February 2010

North Maple Community Bridge

Public Comments Key Themes

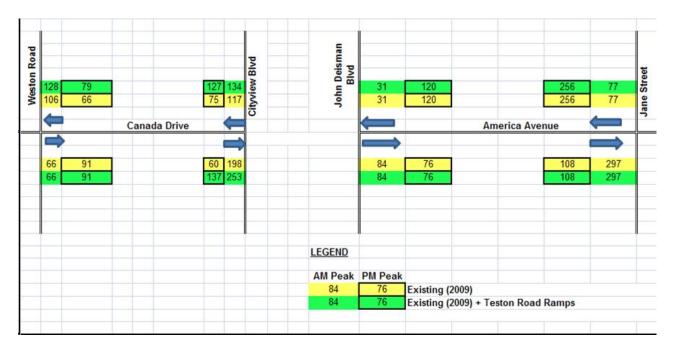
What is the current volume of traffic on America Avenue?

The current traffic (2009) and traffic estimates with the Teston Road ramp open is presented in the following figure. These traffic volumes exclude the America Avenue and Canada Drive bridge connection.

It should be noted that the URS (2003) "The Community of Weston Highlands in the Village of Vellore" report and the Giffels Associates Ltd "Teston Road EA (2003)" report were referenced for the existing 2009 traffic condition. This includes existing 2009 weekday AM and PM Peak Hour Traffic Conditions (with Teston Road and Highway 400 Ramp open).
